Voltage-Based Alternative Repair Criteria

**A Report to the
Advisory Committee on Reactor Safeguards
by the
Ad Hoc Subcommittee on a
Differing Professional Opinion**

Date Completed: February 2001

Figure 3. Schematic Diagram of Natural Circulation in the Primary Reactor Coolant System. On the left, full loop natural circulation is shown. On the right, countercurrent natural circulation through the steam generator is shown.

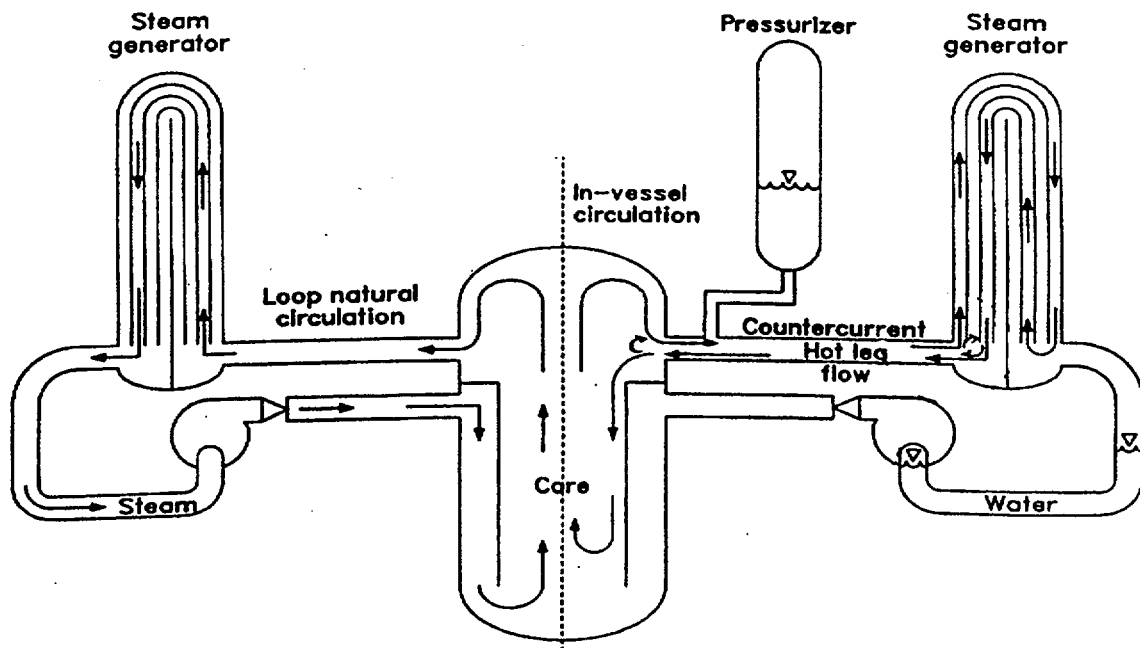
The staff has analyzed the possible evolution of severe accidents and the loads that they place on the steam generator tubes using computer models like SCDAP-RELAP5. These analyses [5] are predicated on the assumption that the "loop-seals" in the primary reactor coolant system remain in place, so there is not a gross convection through the reactor coolant system³. Instead, a countercurrent natural circulation of steam from the degrading reactor core through the steam generator tubes and back to the core is established. A schematic diagram of this natural circulation flow is shown in Figure 3. The analyses done by the staff indicate that heat is transferred to other parts of the primary reactor coolant system by the natural circulation flow, and failure at other locations is likely to occur before a steam generator tube undergoes gross failure as a result of creep rupture. Typically, the surge line is predicted to fail first, followed by failure of a reactor nozzle. The analyses also show that the timing of the failures at the various locations are not greatly different.

³ If a loop seal is opened and the coolant level in the pressure vessel is sufficiently low, an overall natural circulation of high-temperature steam through the steam generator and back into the vessel develops (see the left side of Figure 3.) This overall natural circulation is thought to impose sufficiently high heat loads on the steam generator tubes that the tubes fail whether they are flawed or not. Detailed analyses have not been done, but it is known that additional complexities can develop in the analyses of such scenarios, including episodic re-establishment of the loop seals.

The Ad Hoc Subcommittee concluded that the issue of the possible evolution of severe accidents to involve gross failure of steam generator tubes and bypass of the containment is not yet resolved. The Subcommittee also believes that the issue needs consideration regardless of the criteria adopted for the repair and replacement of steam generator tubes. The issue may be affected by any enhanced leakage that comes from the use of the alternative repair criteria described in GL 95-05. But, the issue is just one of several significant uncertainties that now exist in the assessment of severe accident progression.

Figure 4. Process Used to Estimate Leakage Rate

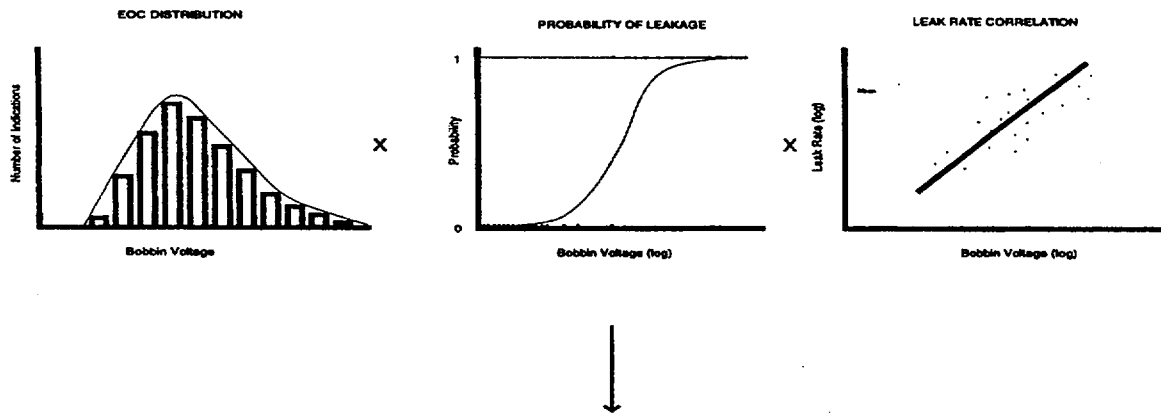
The prediction of the leak rate from tubes in a steam generator during a MSLB accident involves steps shown schematically in Figure 4. The process begins with a determination of a distribution of the number of flaws found during inspection of the steam generator as a function of the magnitude of the voltage signal produced by these flaws. The number of flaws in each voltage interval is increased by a factor equal to the reciprocal of the probability of detection ($1/POD$) of a flaw capable of producing a signal of this magnitude. The resulting distribution is multiplied by the probability that flaws producing signals of a given magnitude will leak. The resulting distribution is then multiplied by the leak rate in each voltage range found from a correlation of the leak rate with signal magnitude. Summation over the various voltage intervals yields a prediction of the leak rate during a MSLB accident.

The staff appears to be relying on a compensation of errors in the process to produce a result that is, overall, conservative. Based on the examples shown to the Subcommittee, the staff-approved procedure is yielding conservative results. The Subcommittee did find that the staff-approved procedure does not readily admit likely improvements in the technologies used to inspect steam generator tubes. A procedure more amenable to change with improving technology would consider the probability of flaw detection to be a function of the magnitude of the signal the flaw could produce and would adjust the number distribution to account for the probability of flaws being present that are capable of producing voltage signals in ranges where none had been found.

Figure 5. Process Used to Estimate the Tube Burst Probability

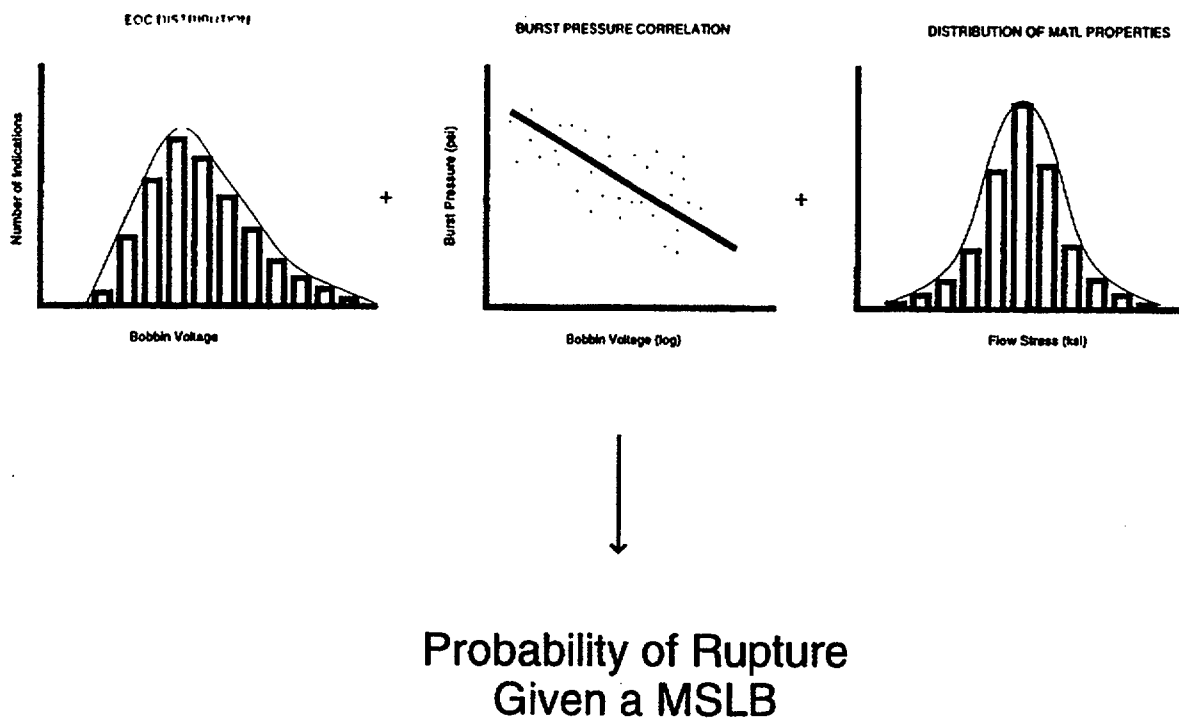
A schematic diagram of the process used for estimating the probability of tube burst is shown in Figure 5. The end of cycle distribution of flaws corrected for the probability of detection and the growth of flaws over the cycle is used just as in the estimation of leakage. This distribution is convoluted with the correlation of normalized burst pressure with voltage. The normalization factor is the flow stress, which is the average of the yield stress and the ultimate stress. The flow stress has a distribution due to the variability of material properties, so the analysis is done using Monte Carlo methods. The Ad Hoc Subcommittee did not examine the distribution of the flow stress. It did examine the correlations of burst pressure with voltage.

The Ad Hoc Subcommittee also examined the database in terms of the sources of the data. Data obtained from tubes flawed in model boiler tests constitute much of the data available for higher voltage signals. These data mesh smoothly with the lower voltage data obtained from tubes removed from service. That is, there was no readily apparent indication that the two data sources yielded results that were indicative of radically different population distributions for flaws.

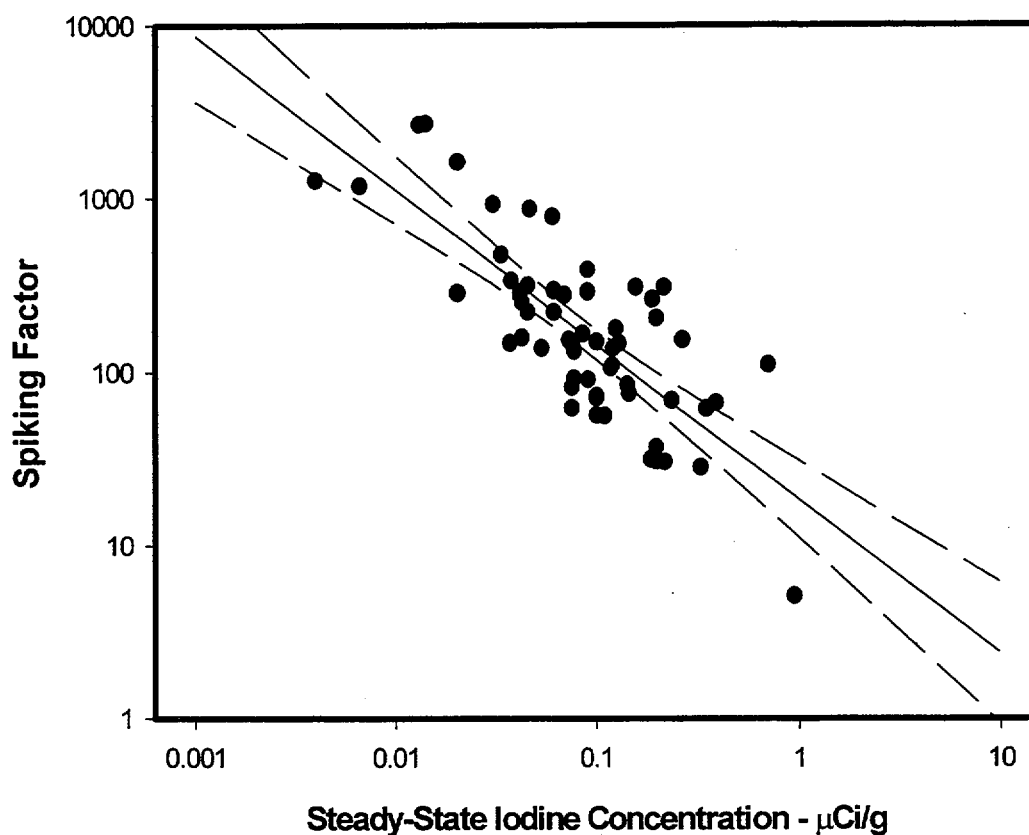
The DPO author contends that the spiking factor used for the accident analyses is too low when the Technical Specification limit on the iodine concentration in the coolant during normal operations has been reduced. He argues that the spiking factor increases with decreasing steady-state iodine concentration. Data collected and reviewed by Atwood and Sattison [17] substantiate the claim made by the DPO author (See Figure 6). A phenomenological understanding of this correlation

where $N = 58$ is the number of data points used to construct the correlation. These bounds are indicated in Figure 6 by the dashed lines on either side of the solid line calculated from the correlation.

The DPO author rightly contends that the iodine spiking factor seems to exhibit a correlation with the initial iodine concentration in the coolant. But, it might be argued that for accident analyses the appropriate spiking factor to use is that found from the empirical correlation using the actual operational iodine concentration rather than the Technical Specifications limit adopted by the licensee, whether it is 1.0 $\mu\text{Ci/g}$ or 0.01 $\mu\text{Ci/g}$. Such a procedure would be inconsistent with the approaches that have long been used in the analysis of design basis accidents. The Ad Hoc Subcommittee also believes that the empirical, linear correlation of spiking factor with initial iodine concentration to the very low initial iodine concentrations typical of many plants today without explicitly accounting for data uncertainties and variations in the mechanisms that lead to operational levels of iodine in the coolant is without sound technical foundation.

Data are available to develop a correlation of the spiking factor with steady-state iodine concentration for analysis of steam generator tube rupture events. If this is done, the correlation should be used with whatever Technical Specification limit on the iodine concentration has been adopted by a licensee rather than the operating iodine concentration typical of the plant. This will maintain consistency with past practices in the analyses. If the staff continues to believe that the spiking factor is greater in a main steamline break because of high differential pressures, another specification of the spiking factor needs to be developed. The Ad Hoc Subcommittee believes, however, that it would be better for the staff to develop a more realistic mechanistic understanding

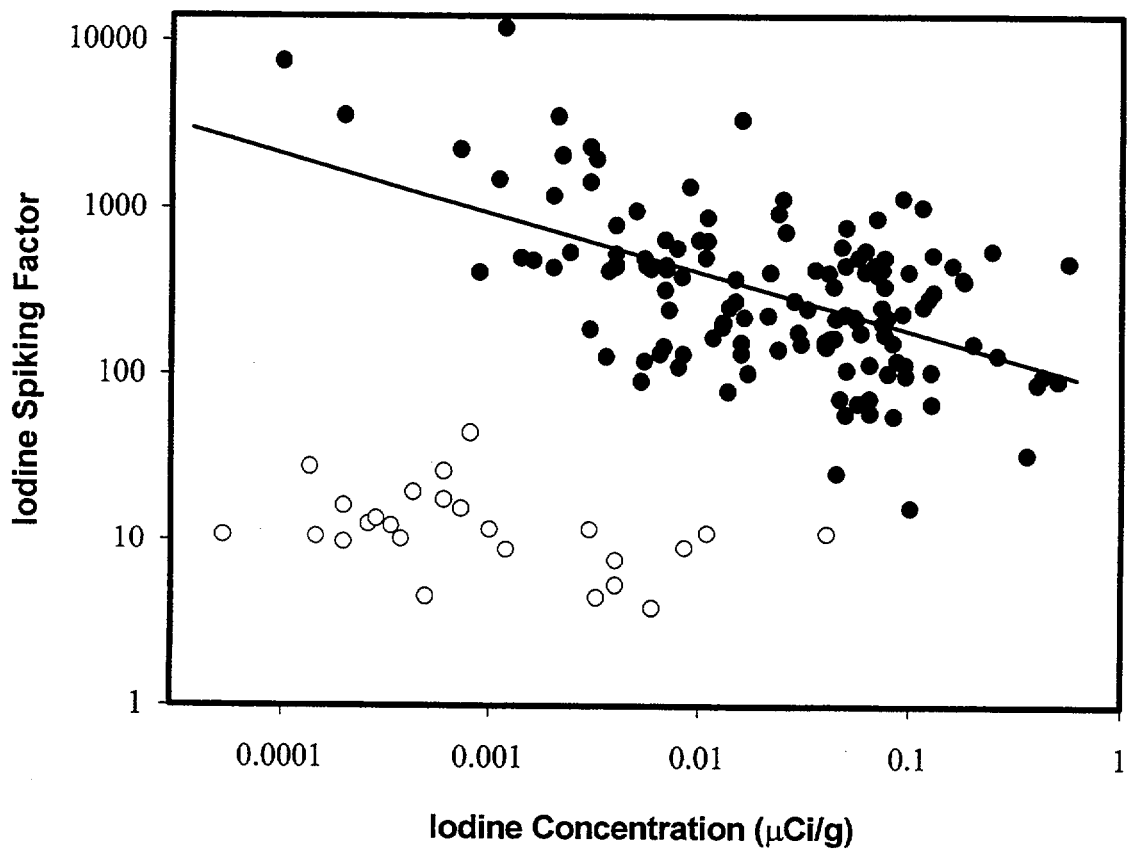
The staff provided the Ad Hoc Subcommittee with an expanded data set on spiking factors. The pedigree of this database is uncertain, but it definitely is not the database used to prepare plots of spiking factor as a function of the initial, steady-state iodine concentration of the coolant shown to the Subcommittee and included in the staff's responses to the DPO. This database seems to be composed of two populations (See figure 7). In one population, the spiking factor does exhibit a dependence on the initial, steady-state iodine concentration. Spiking factors from the other
